# **APPENDIX A.** HCC Response – Downend Road

# Land To The East Of Down End Road Fareham

Outline planning application with all matters reserved (except the means of access) for residential development, demolition of existing agricultural buildings and the construction of new buildings providing up to 350 dwellings, the creation of new vehicular access with footways and cycleways, together with associated highways, landscaping, drainage and utilities.

### Drawing ITB12212-GA-051 Rev B

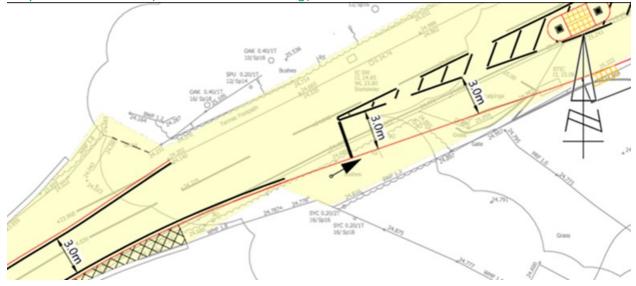
• The drawing is still missing dimensions for the eastbound lane, north side of the bridge despite HCC requiring a fully dimensioned drawing. Dimensions are shown on drawing appendix N drawing 56 A Only westbound shown (see extract from drawing(

Can we have a drawing with all dimensions please sent over. I don't see an issue with this and it being sent to the planning authority for reference, if nothing changes they wont need to reconsult on it.

SCALE @ A3:	CHECKED:	APPROVED:		
1:500	TW	TW		
FILE REF:	DRAWN:	DATE:		
ITB12212	MC	18.08.	17	
DRAWING No:				
ITB12212-GA-014				
PROJECT No:		RE	V:	
ITB12212 E

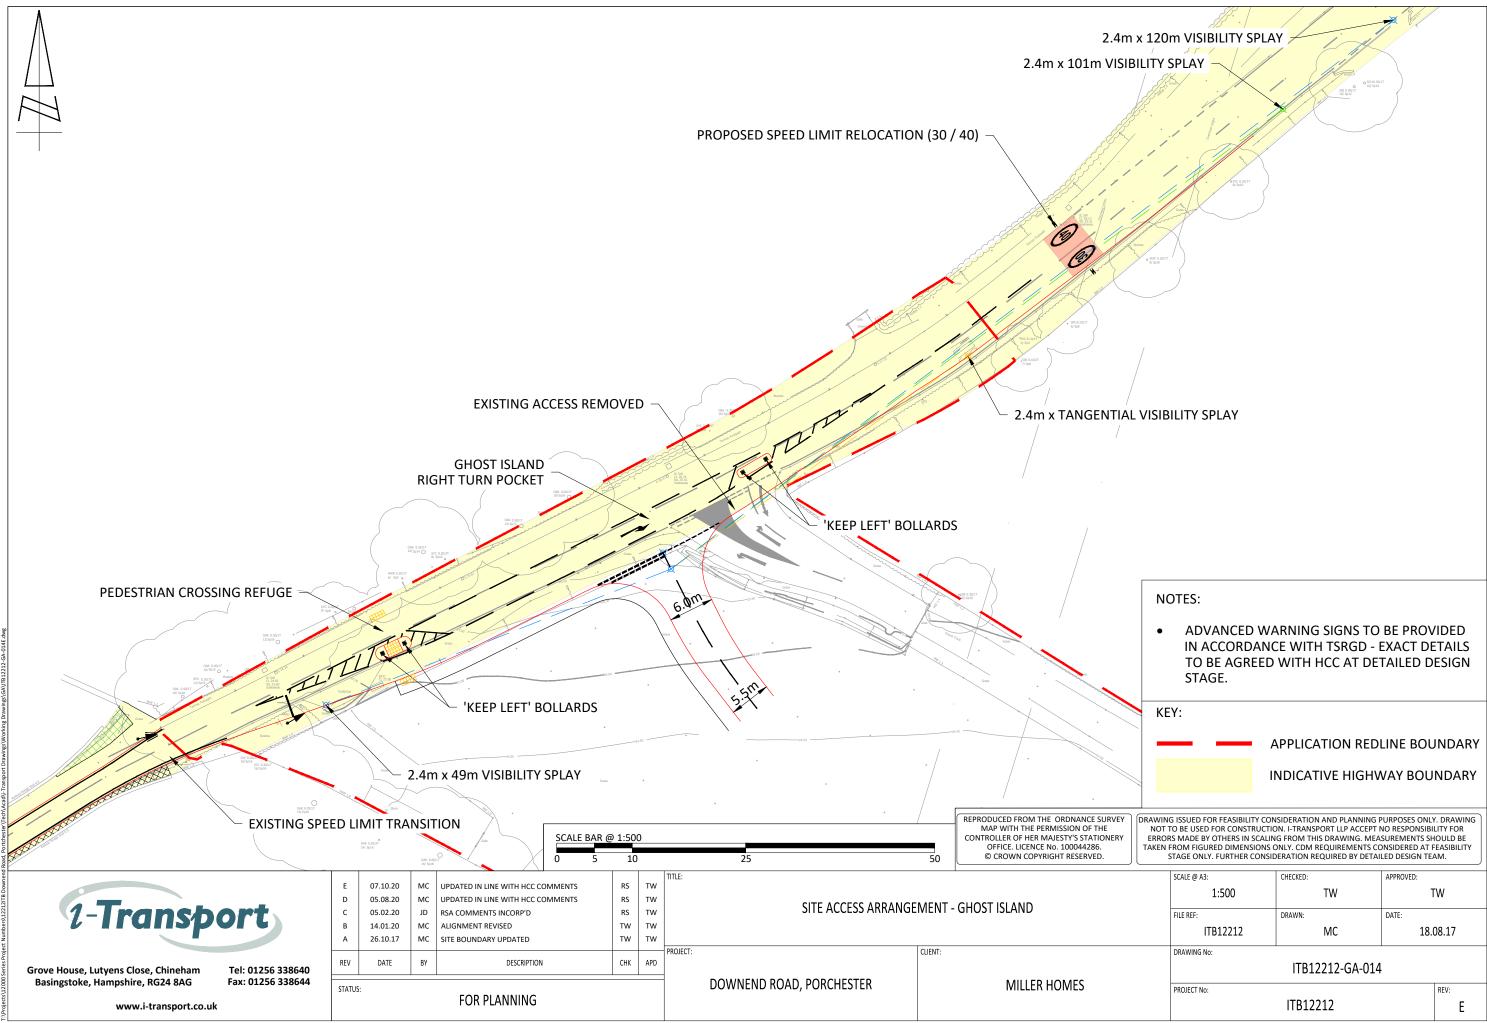
#### Drawing ITB12212-GA-014 Rev D

In order for the design to comply with TG3 and as you are required to update the drawing anyway can you
please demonstrate the visibility splay re-calculated to the current vehicle speeds and shown to the channel
line. I do have a note that the visibility splays are not in accordance with the 2019 recorded speeds at 59m
northbound. I am seeking some clarity on this but have been unable to do so before sending this email and
didn't want to delay. We can catch up on this matter early next week.

As above, we already demonstrated a 120m splay to the channel line which is in excess of the TG3 requirement even using the highest recorded speed. We have nevertheless added a further splay based on TG3 calculation of the highest speed (101m north). In practice much greater visibility is achievable from the junction.

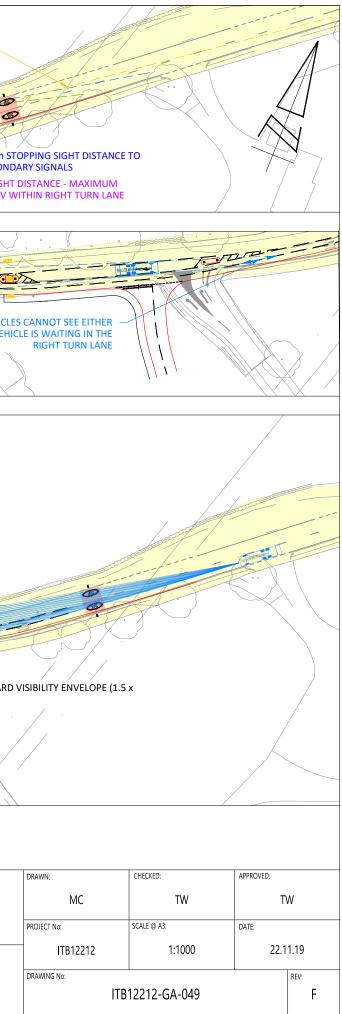
#### Drawing ITB12212-GA-049 Rev E, 062 (Horizontal and Vertical forward vis Drawings)

• We have a significant concern regarding the provision of 160m forward visibility to the primary signal. As shown on drawing 49E the visibility line passes directly through the central refuge in advance of the primary signal which would include high level signs. These signs would obscure visibility to the primary signal at 160m reducing it below the necessary distance. This visibility splay also cuts into the vegetation on the west side of the road. Over time left unchecked this vegetation will further reduce forward visibility to the primary signal. Moving the stop line and primary signal to the north (eg 3-5 metres) to the position of the existing 30mph sign should reinstate the 160m visibility by avoiding the signs on the refuge and the vegetation on the offside. It would also address the tracking issue identified in point 1. The stop line should therefore be relocated accordingly.
